Addendum No. 2
December 10, 2021

Project: Harrisburg High School - 9th Grade Academy
Sioux Falls, South Dakota
Architecture Incorporated Project #2904

Architect: Architecture Incorporated

FIRST FLOOR PLAN - AREA A - VENTILATION & A/C

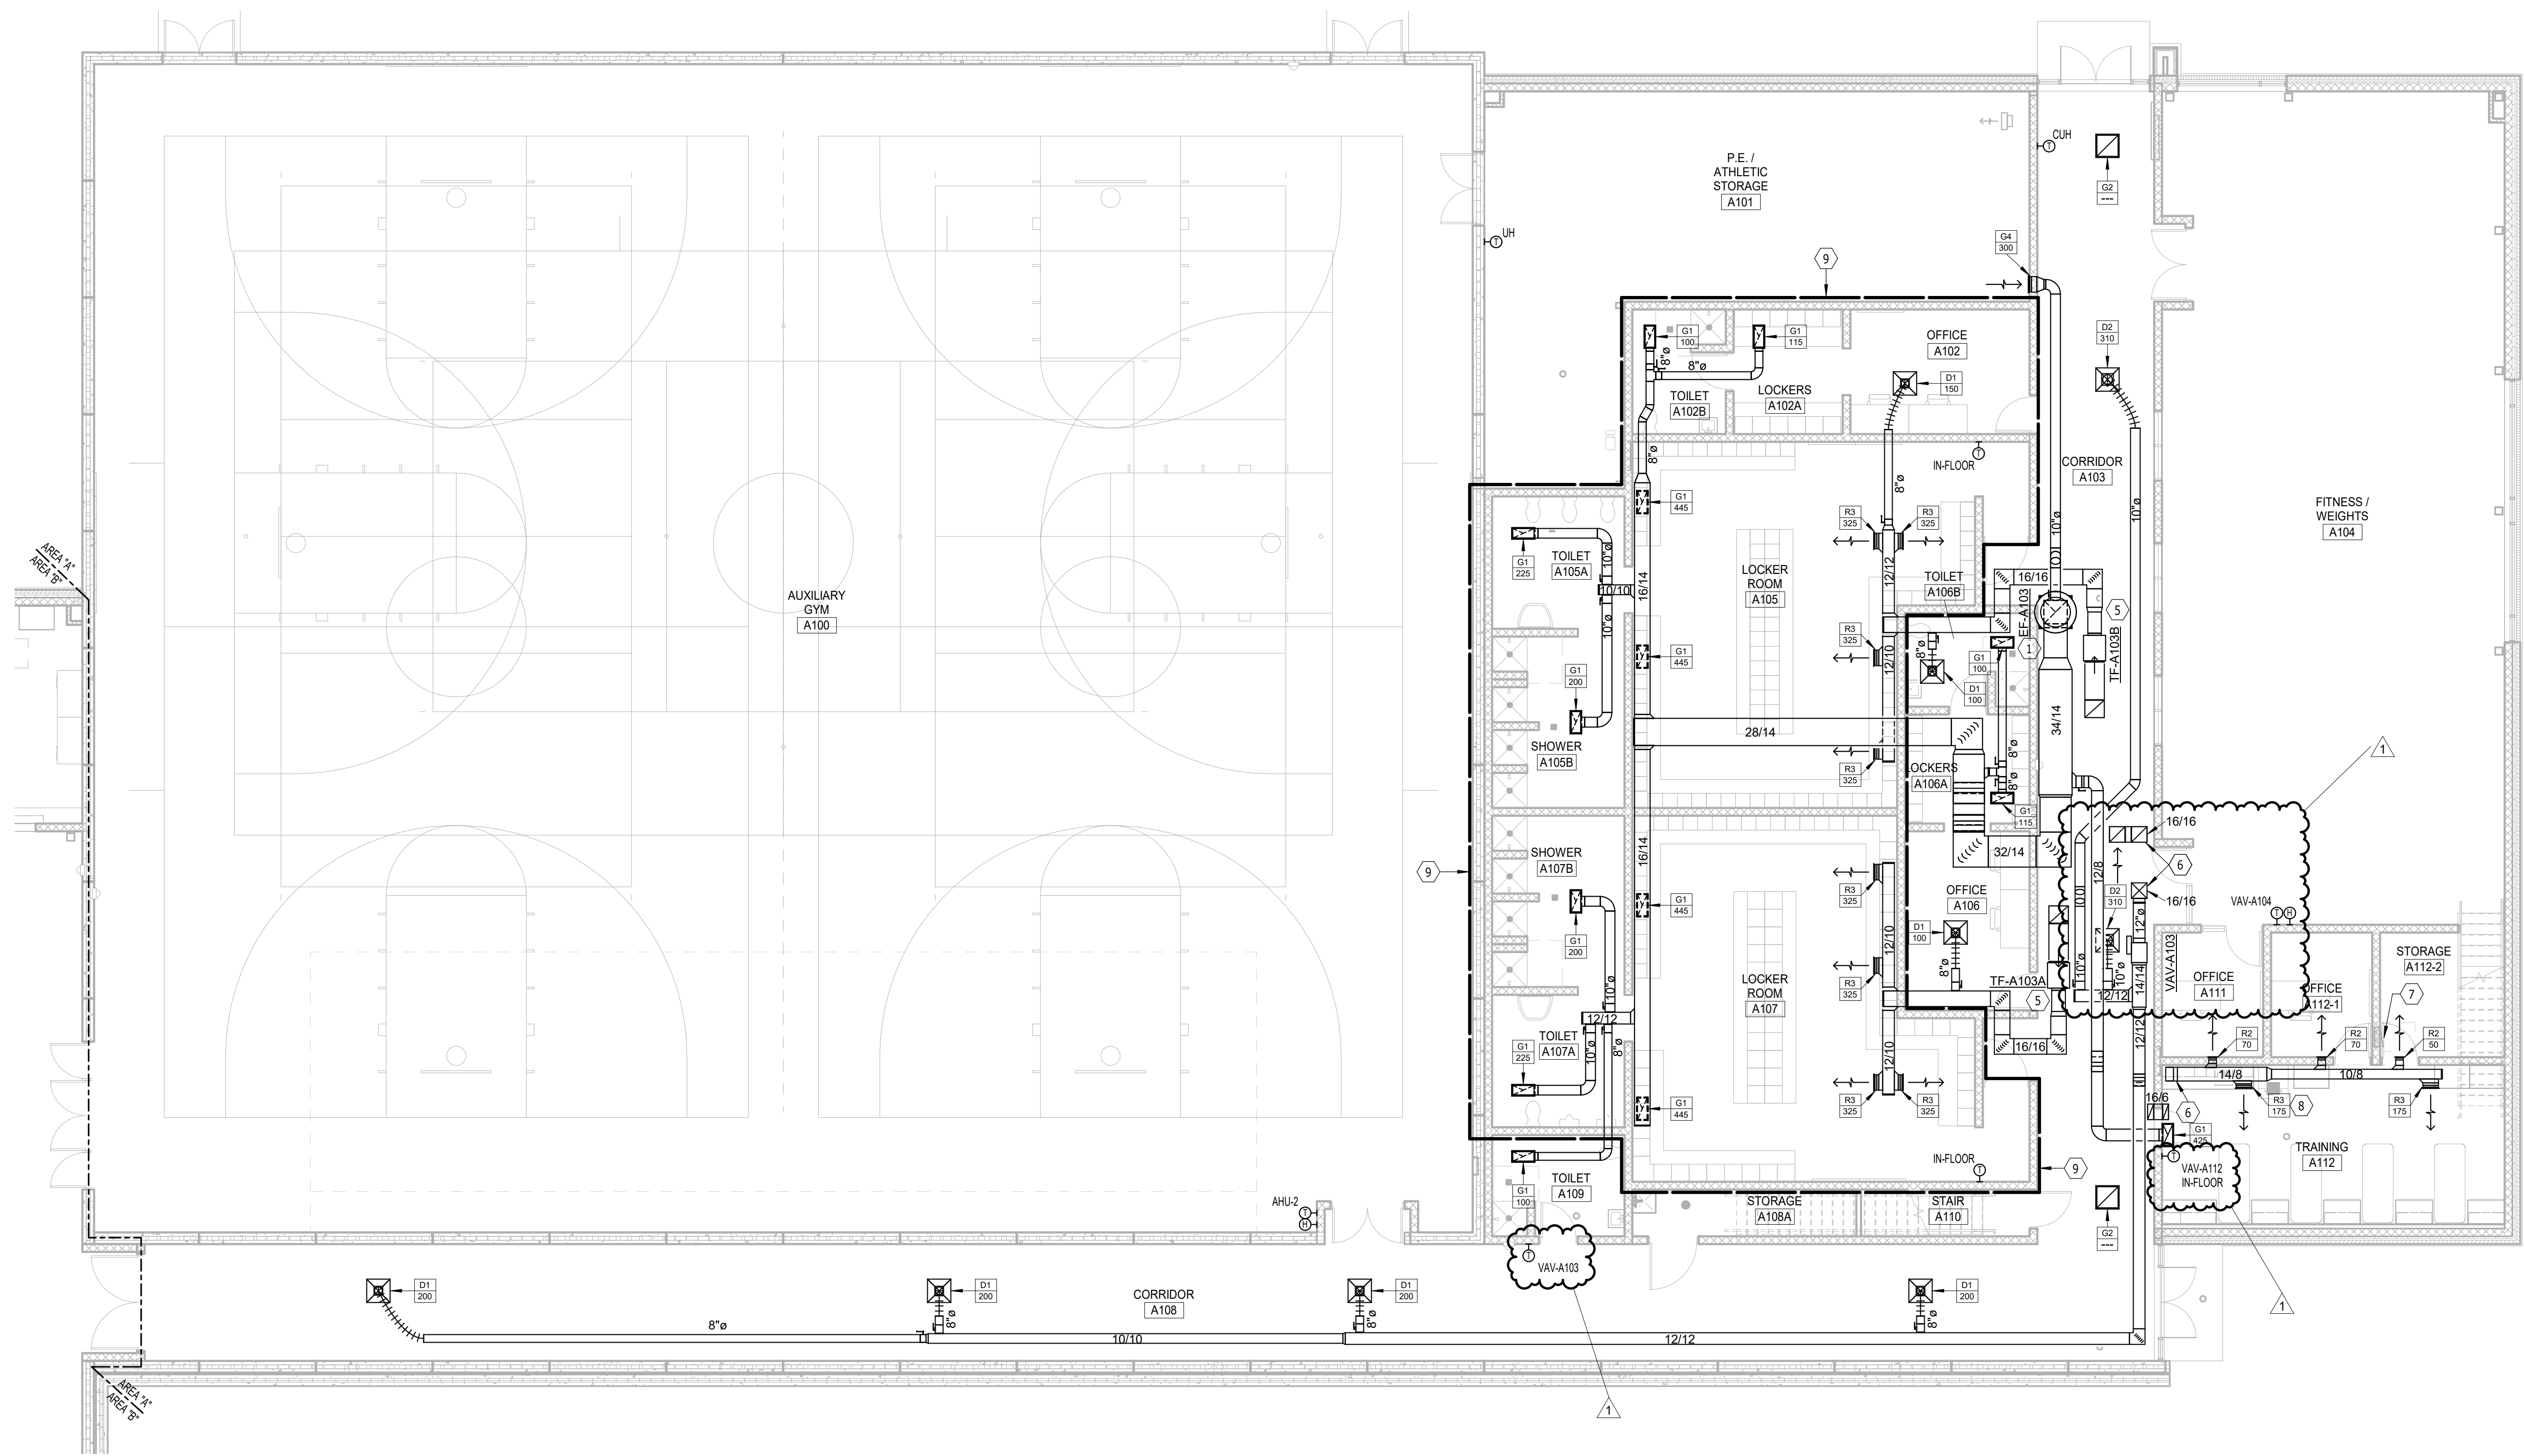
- a) Revise supply and return duct drops. Add VAV-A104, thermostat for VAV-A112 in Training A112 and thermostat for VAV-A103. Refer to revised drawing sheet 8.40-1A, ADDM M2, dated 12/10/21.

Sheet Contents **FIRST FLOOR PLAN - AREA B - VENTILATION & A/C**

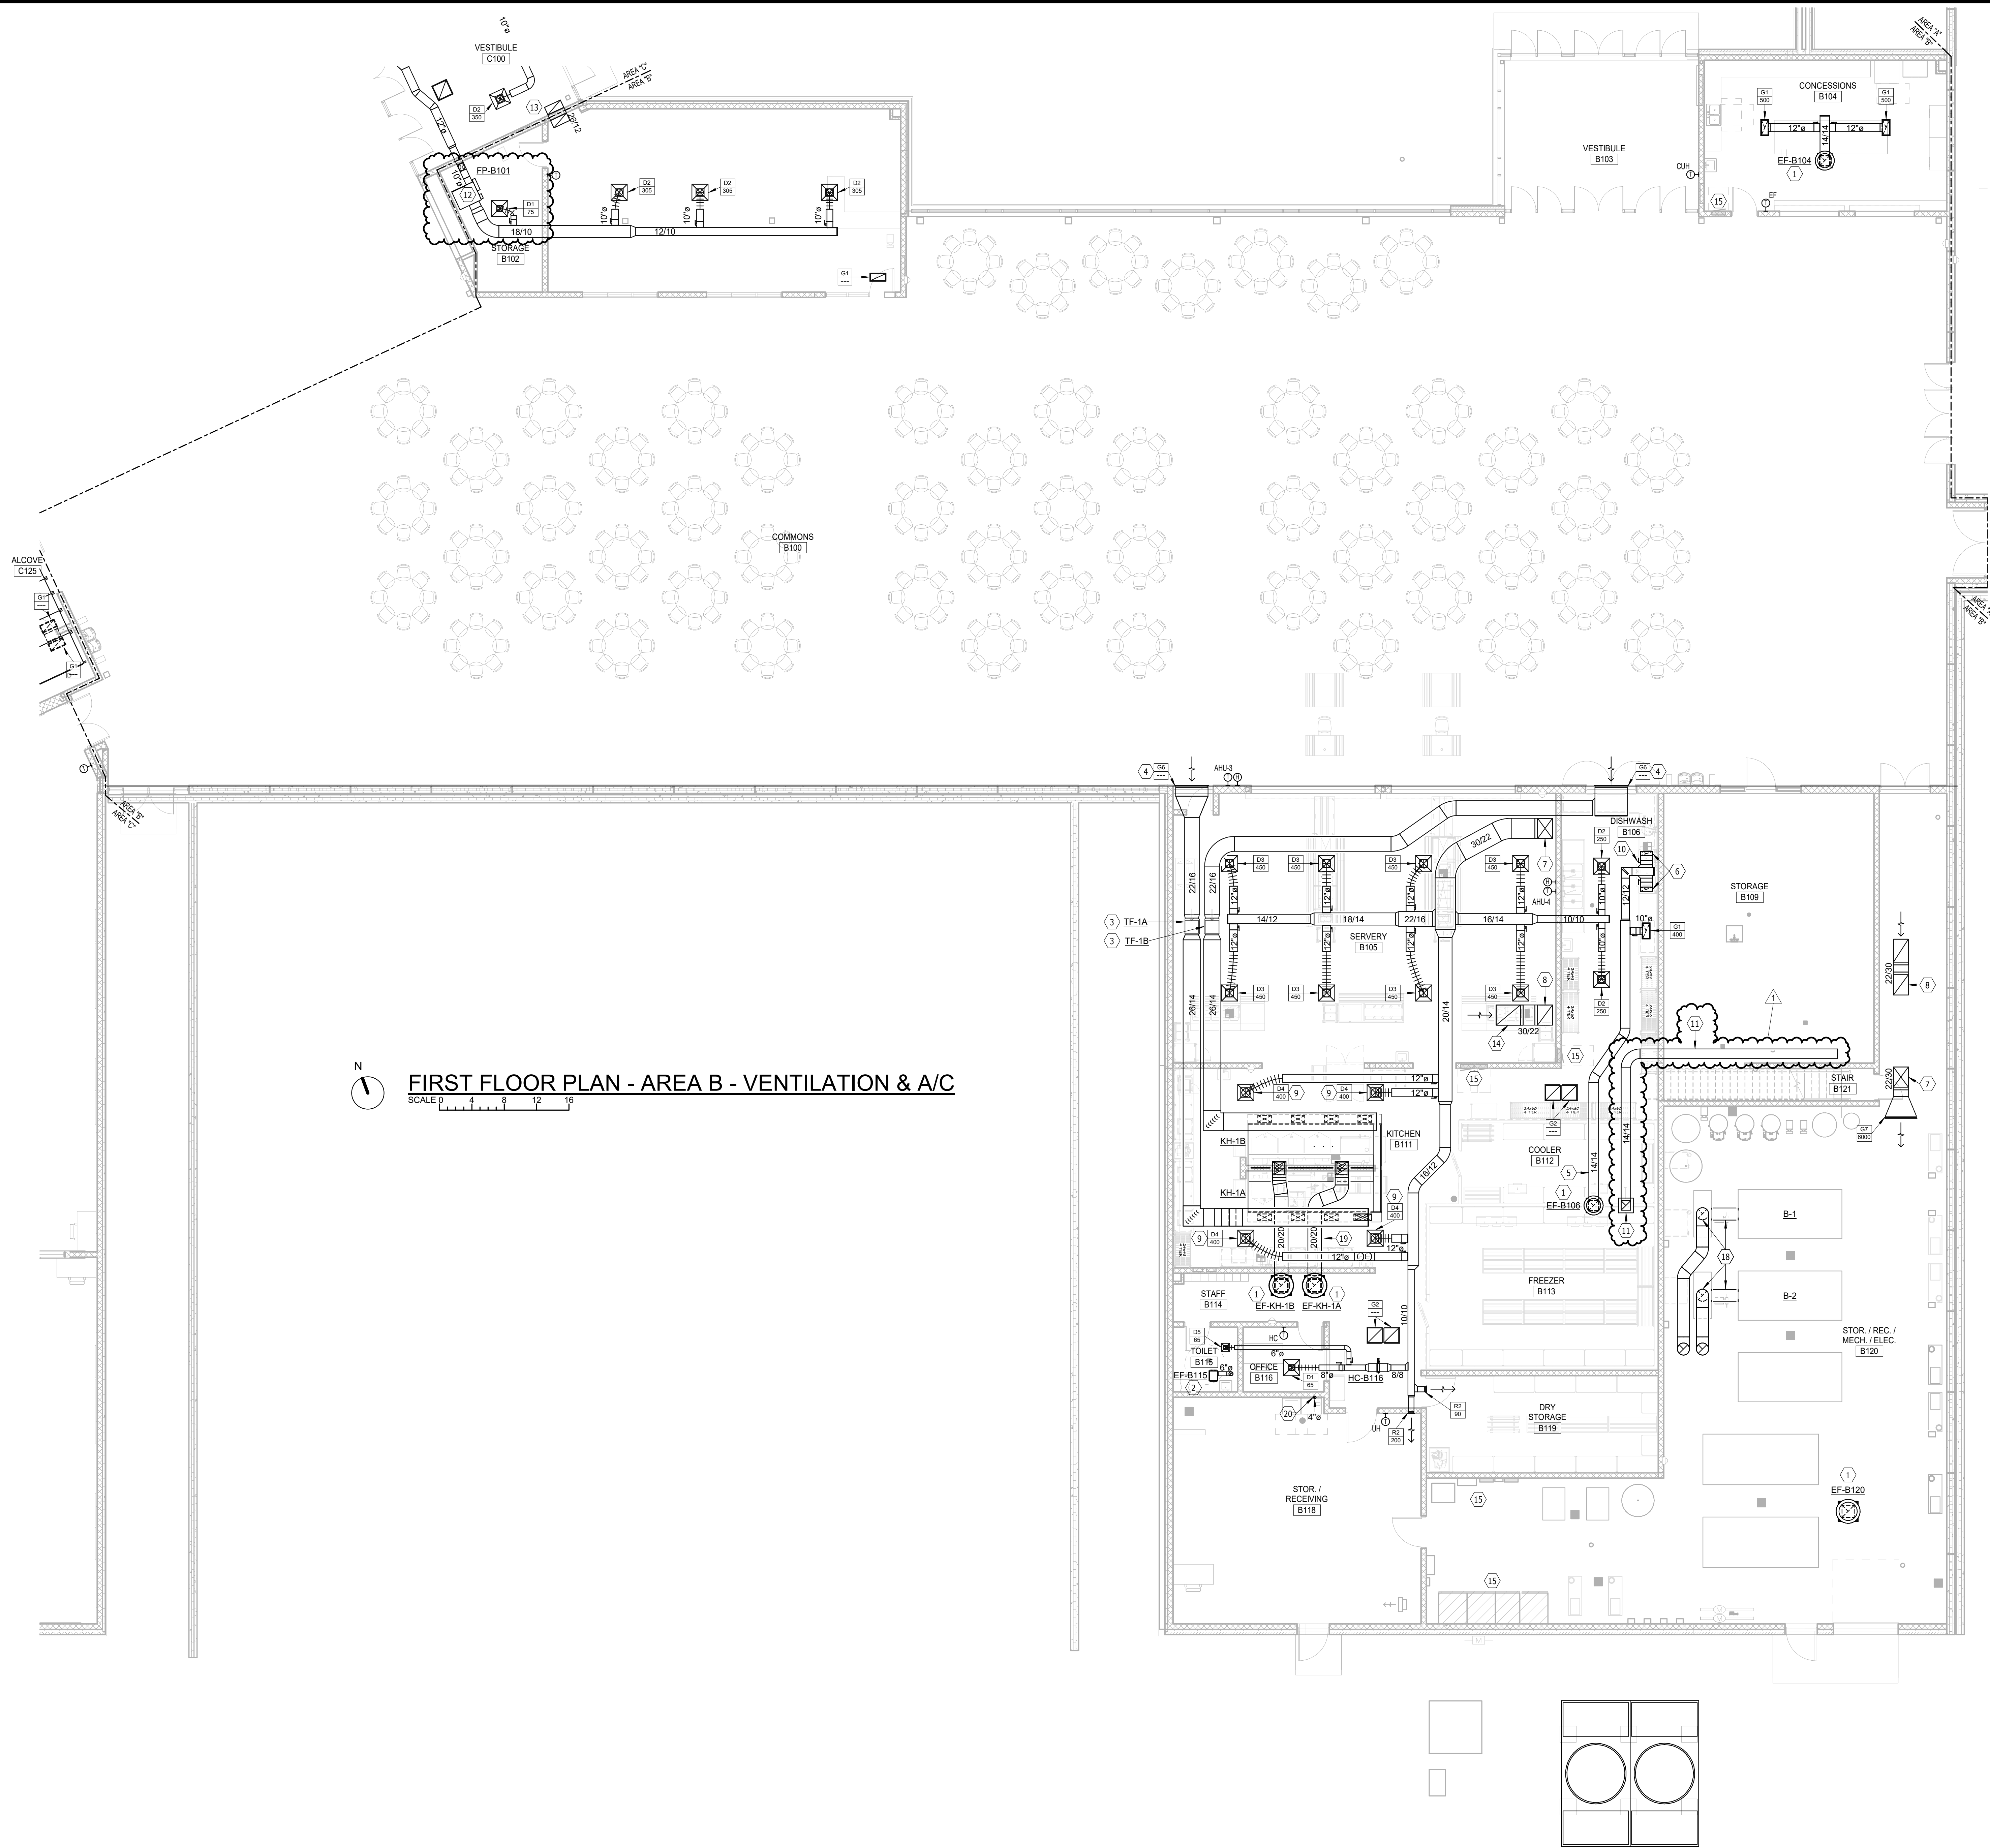
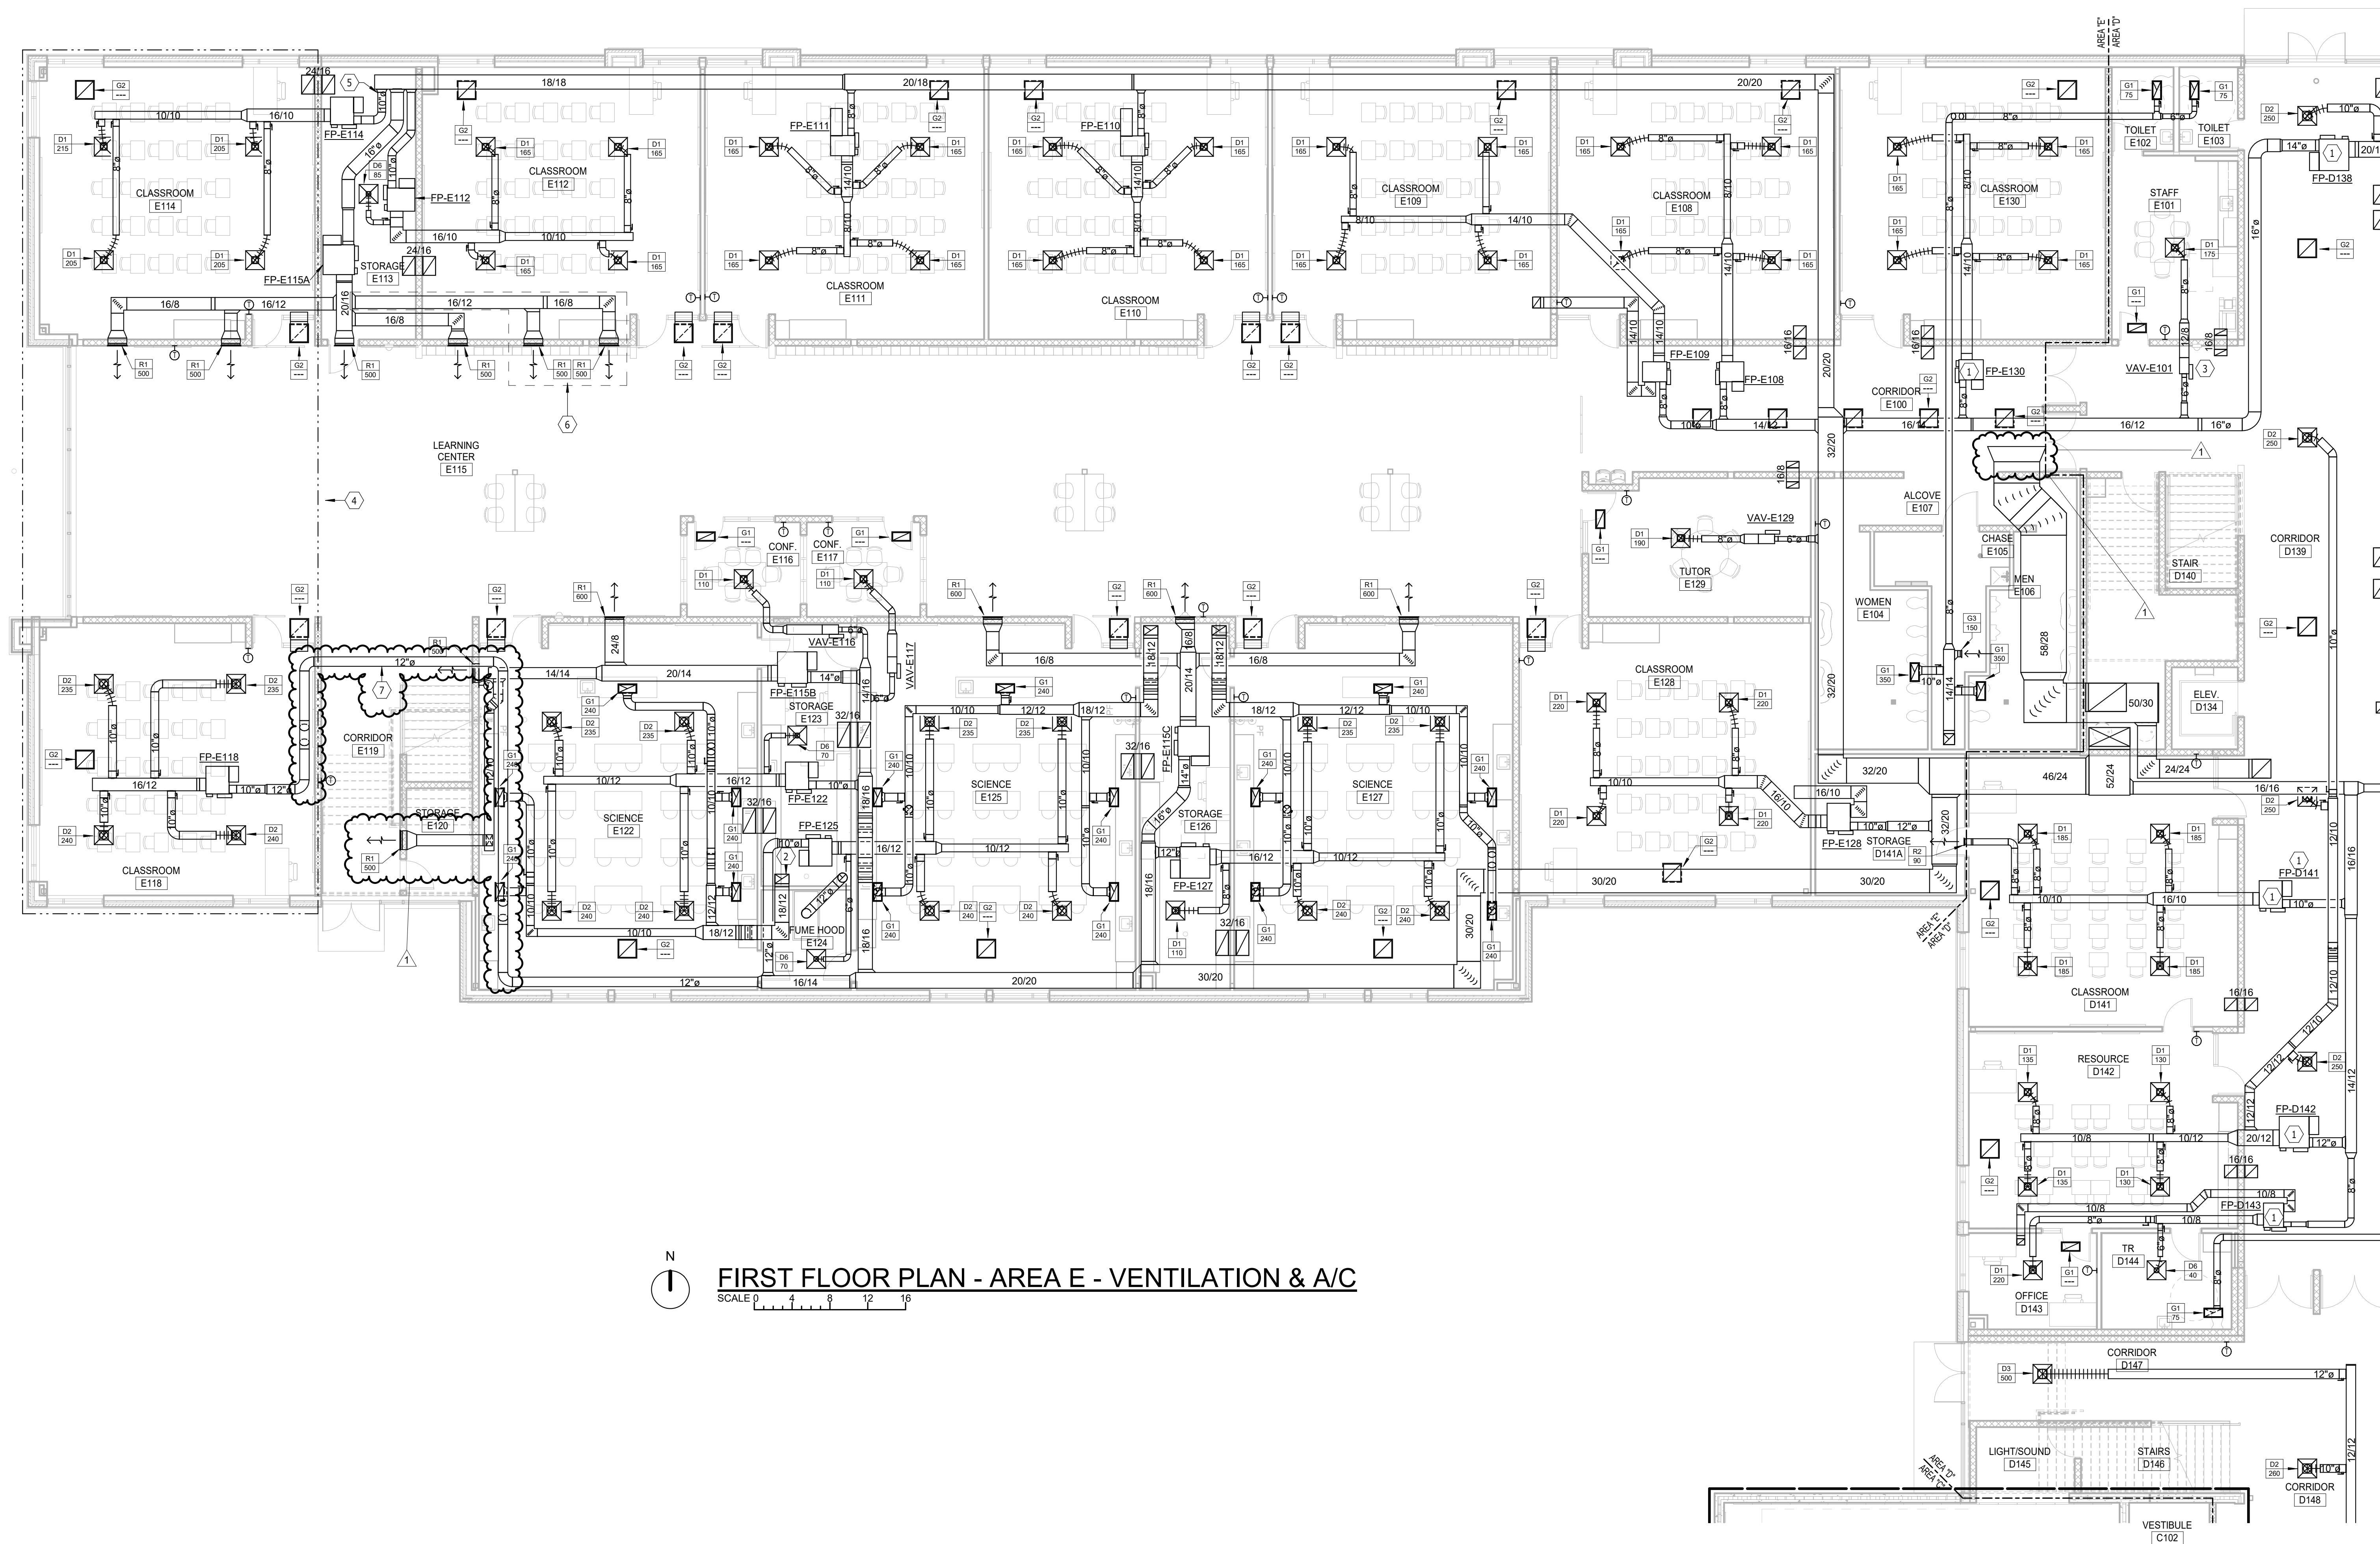
- a) Revise note 11 to add **PROVIDE INSULATED ROOF CURB FOR FUTURE FAN LOCATION**. Refer to revised drawing sheet 8.40-1B, ADDM M2, dated 12/10/21.
- b) Revise location of FP-B101. Refer to revised drawing sheet 8.40-1B, ADDM M2, dated 12/10/21.
